Value Engineering Study &  
Constructability Review

***US 127 ALBANY BYPASS***  
***CLINTON COUNTY, KENTUCKY***  
***ITEM NUMBER 8-260.02 & 8-260.10***  
***VE STUDY NUMBER 201103***

**Final Report**

URS conducted a Value Engineering (VE) study and Constructability Review of the US 127 Albany Bypass project in Clinton County, Kentucky. The item number is 8-260.02 and 8-260.10. The topic was the 95% design submission prepared by Entran and HMB for the Kentucky Transportation Cabinet (KYTC).

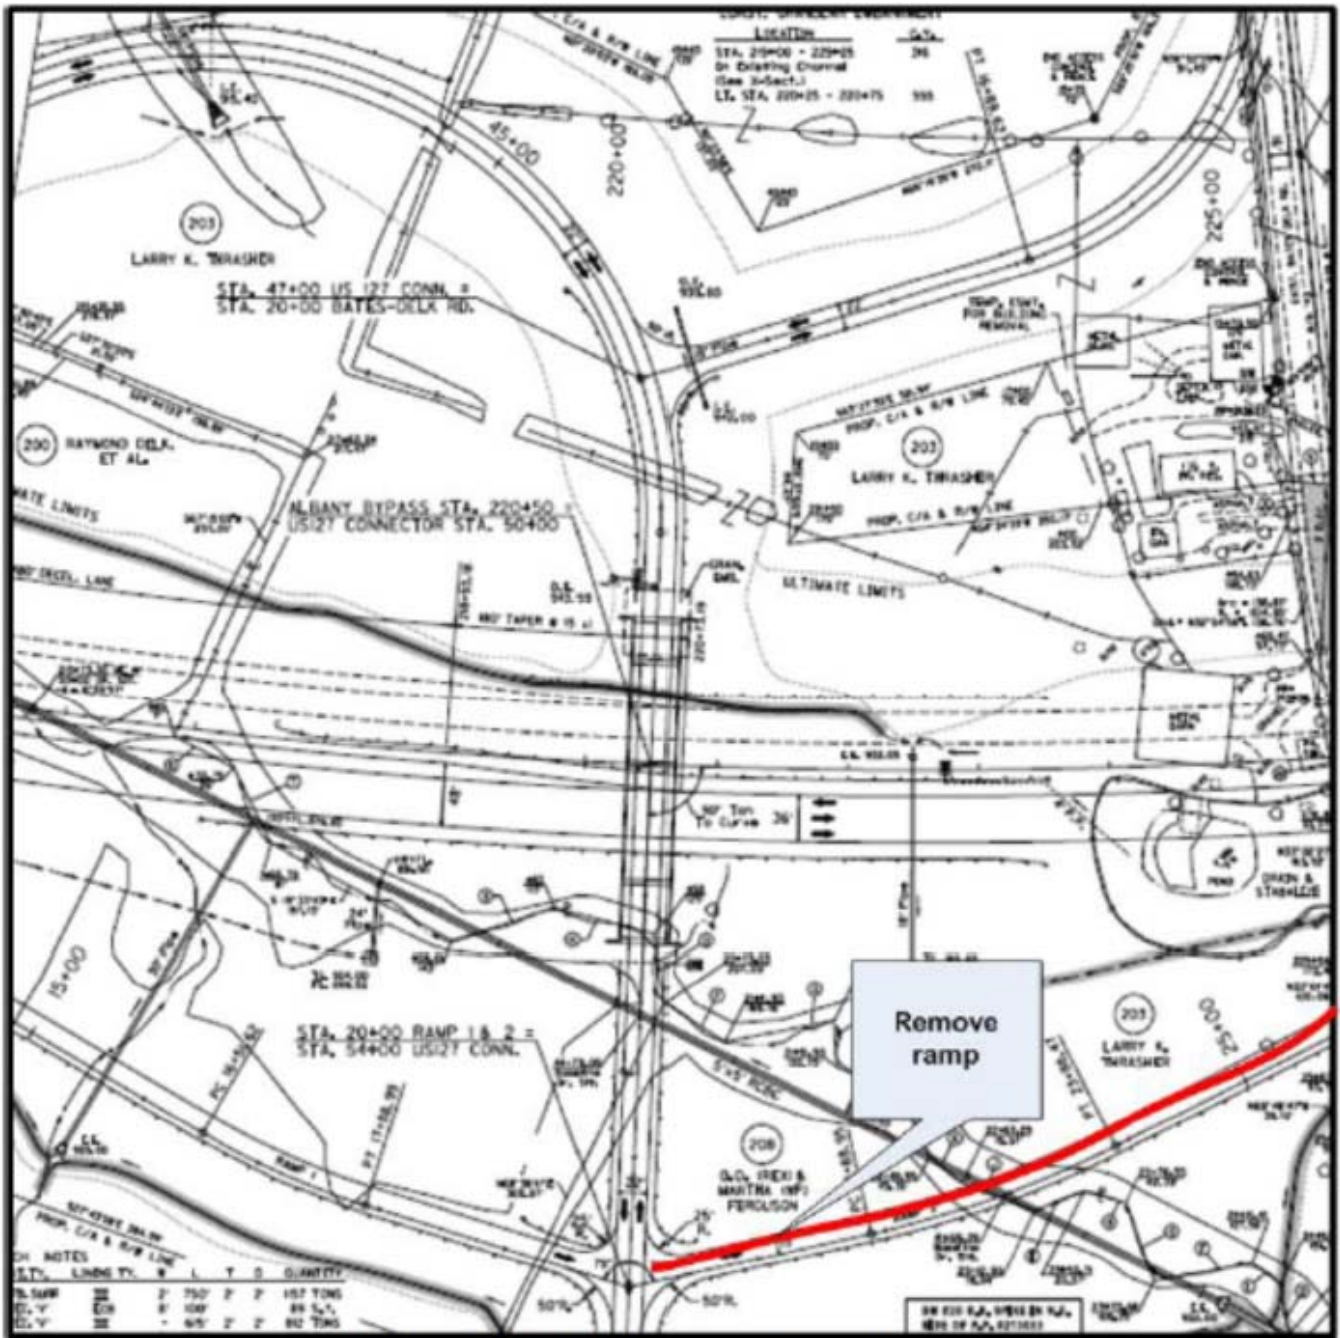
Utilize a left turn option from the jughandle at US 127 Connector and eliminate the mainline northbound on-ramp.

The original design calls for a northbound on-ramp for traffic turning from US 127 to Albany Bypass.

The VE Team recommends the elimination of the northbound on-ramp.

There is not a significant need for this ramp. The turning movement for US 127 to the Albany Bypass is very low (30 vehicles projected in the peak hour in 2030). By eliminating the on-ramp, drivers have two basic alternatives: use the jughandle ramp and then turn left to head north or divert along other routes such as KY 738 to reach the bypass. The channelization island at the base of the ramp would need to be removed.

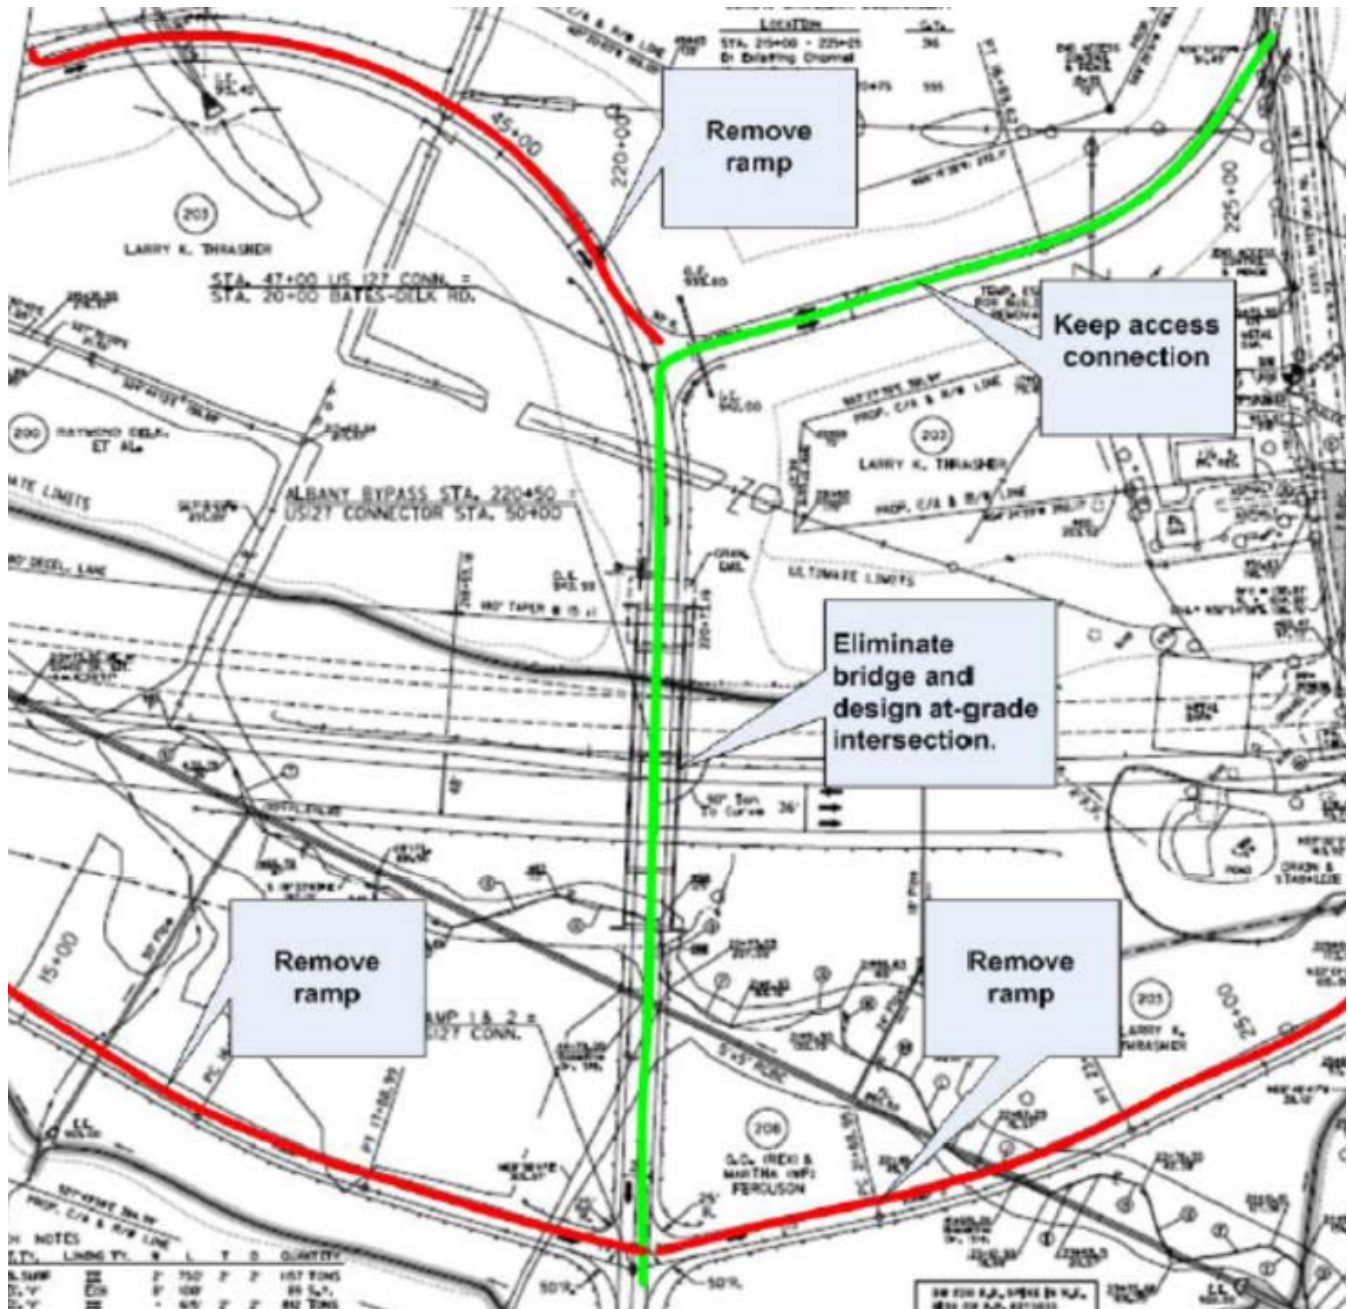
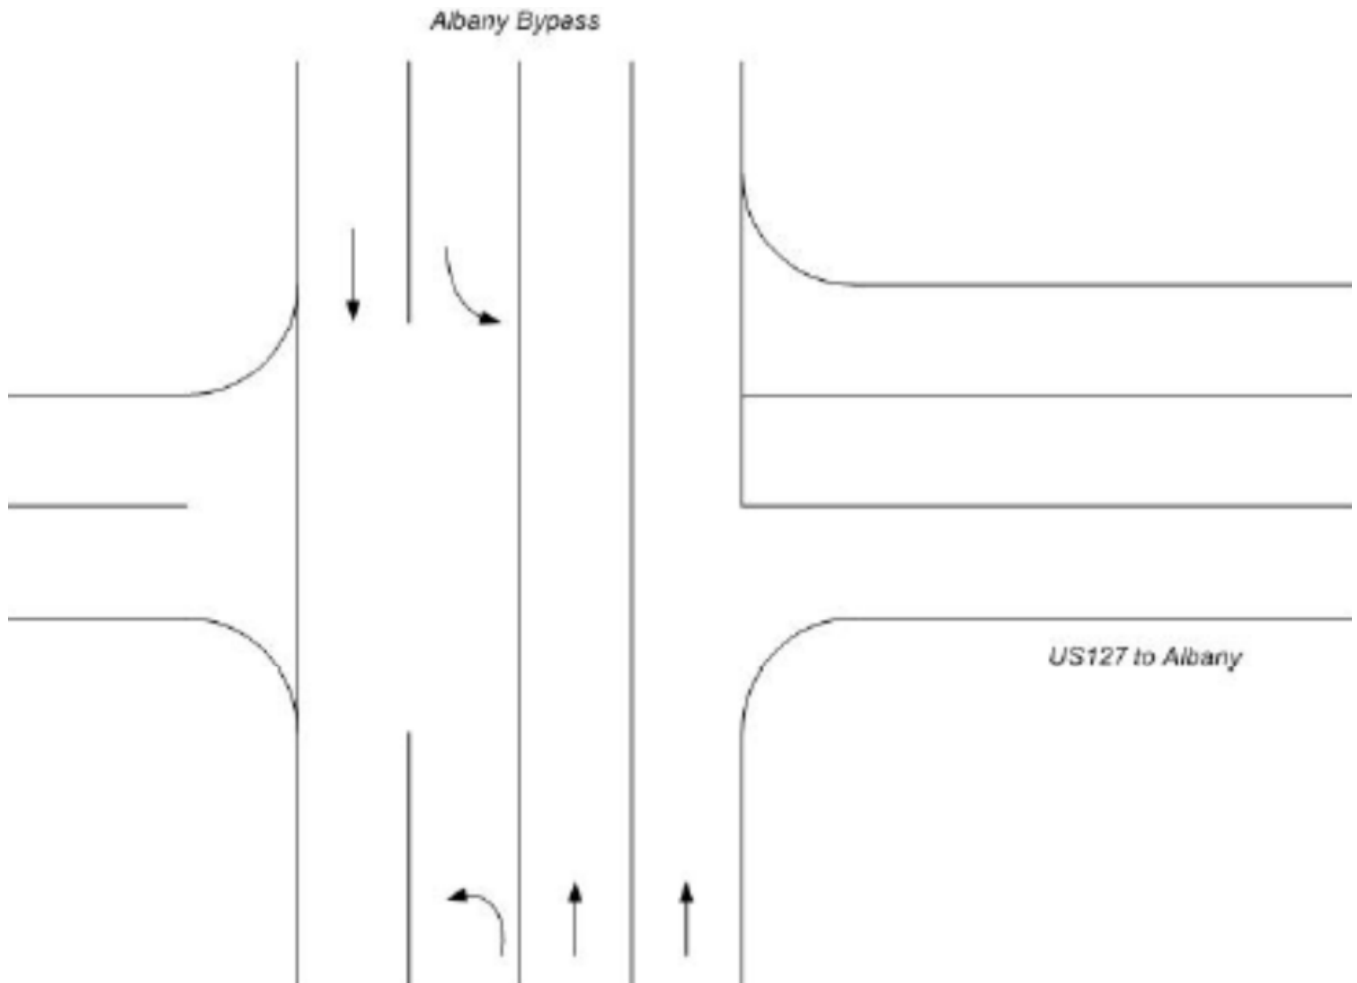
Utilize an at-grade intersection for the US 127 Connector in lieu of grade separated interchange.

The original design calls for a grade-separated interchange where the existing US 127 ties into Albany Bypass.

The VE Team recommends the construction of an initial at-grade intersection.

Based on the traffic forecast figures, a grade-separated interchange will not be needed in the intermediate future. The traffic forecast has a base year of 2002 and a future forecast year of 2030. Based on the traffic counts south of Albany on US 127, traffic volumes have not increased between 1997 and 2010 (3900 vs. 3960 vehicles per day). This indicates that the forecasts may be higher than what is happening in reality. With traffic growth increasing at a slower rate, an unsignalized intersection appears to adequately handle traffic volumes, even during the peak hour. Through movement on US 127 and the bypass operate with almost no delay. During the peak hour, the approach delay on the old US 127 is 47 seconds with only an average queue of seven vehicles.

By removing the ramps, the large box culvert design can be changed. Currently, there is approximately 1,400 ft of 5 ft x 5 ft RCBC. This can be reduced to 200 ft or less of RCBC with the change of design.

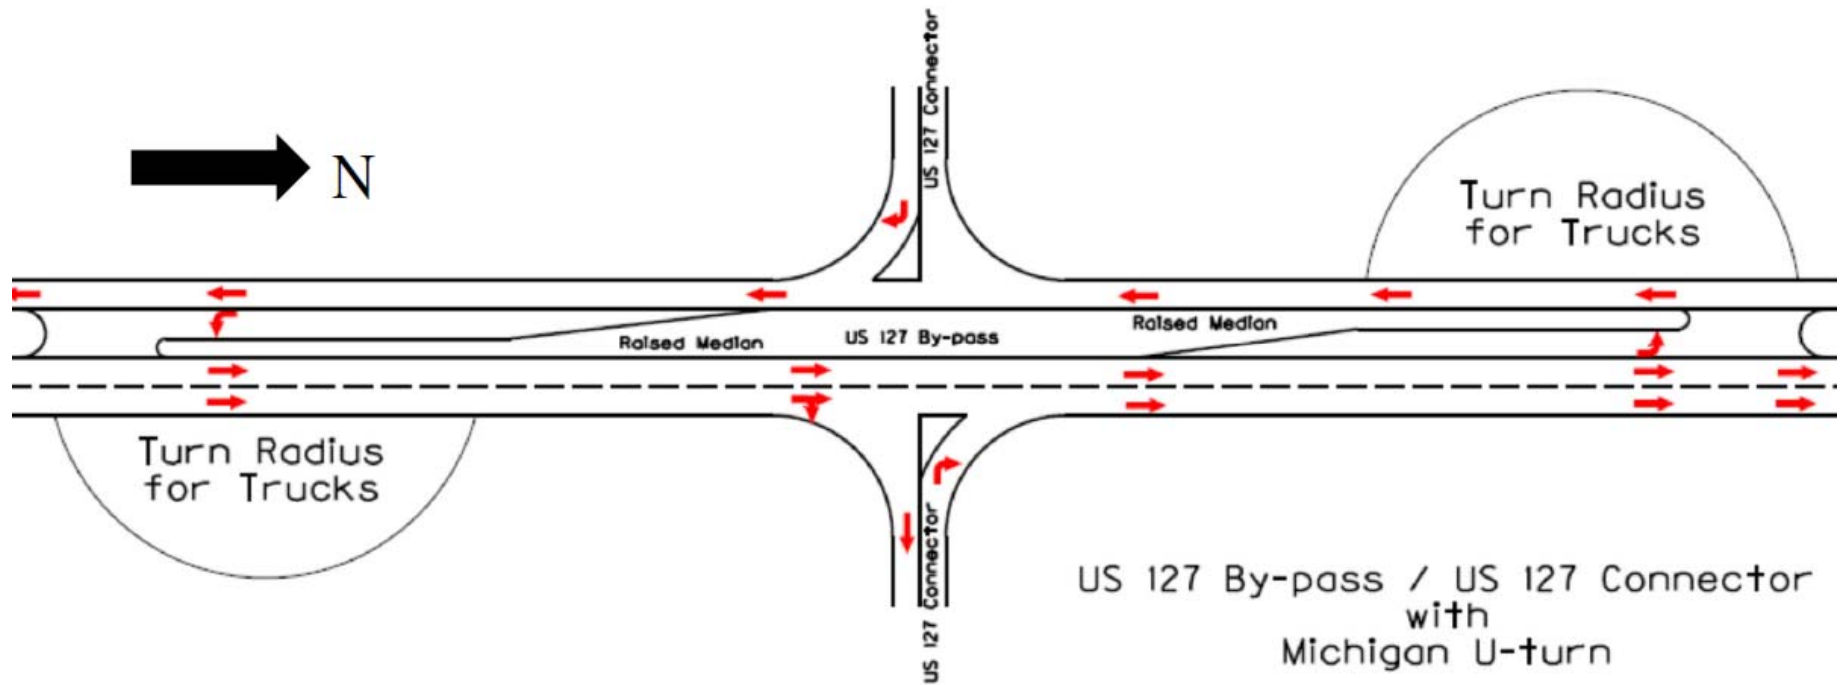
Utilize two Michigan U-Turns at the intersection of the US 127 Connector in lieu of the proposed interchange.

The original design specifies a grade separation at this location with a north bound off-ramp, a north bound on-ramp and a jughandle in the southwest quadrant. The jughandle accommodates southbound traffic that desires to travel east on the proposed US 127 Connector and westbound traffic that wishes to travel south on the US 127 Bypass from the US 127 Connector.

The VE Team recommends constructing an at-grade intersection with Michigan U-Turn movements that will accommodate traffic wishing to turn left from the US 127 Connector to southbound US 127 Bypass and southbound US 127 Bypass wishing to turn left to eastbound US 127 Connector.

The turning movement volumes indicate that this intersection will function at an acceptable level with this configuration. This configuration will allow for safe, continuous traffic flow of the US 127 Bypass without stops from a signal and for a much lower cost than the proposed design. The costs associated with Ramp 1, Ramp 2, Bridge over US 127 Bypass and partial elimination of the US 127 Connector will reduce construction costs and future maintenance costs of the bridge and ramps.

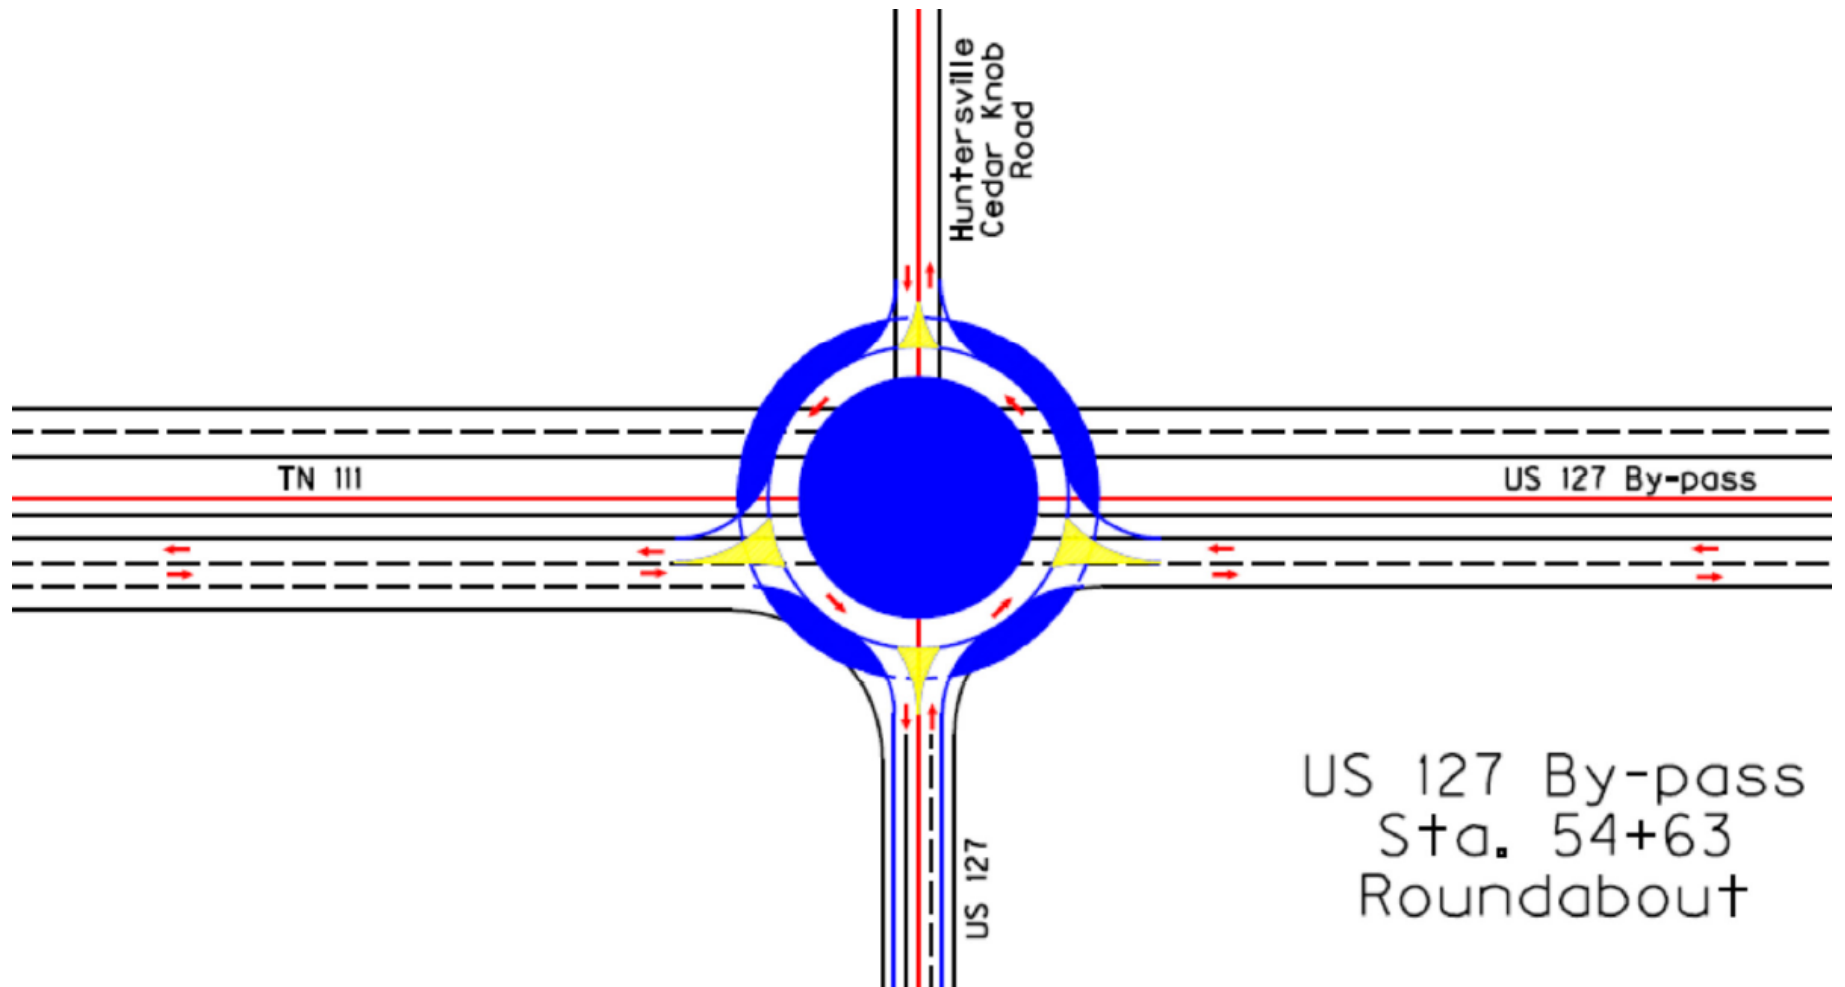
Utilize a roundabout at US 127 and State Line Road in lieu of unsignalized intersection.

The original design specifies an unsignalized intersection left, thru, right turn lanes northbound; left and thru/right turn lanes southbound; left, thru/right turn lanes westbound; and a left/thru/right lane eastbound.

The VE Team recommends constructing an initial one-lane, ultimate two-lane (or major-minor) roundabout at this location.

The incorporation of a roundabout designed to accommodate initial and ultimate will eliminate the need to modify the intersection with future increases in traffic movements thru this intersection, thereby minimizing the inconvenience to the traveling public. Modifications to accommodate a two-lane roundabout in the future would involve minimal construction costs.
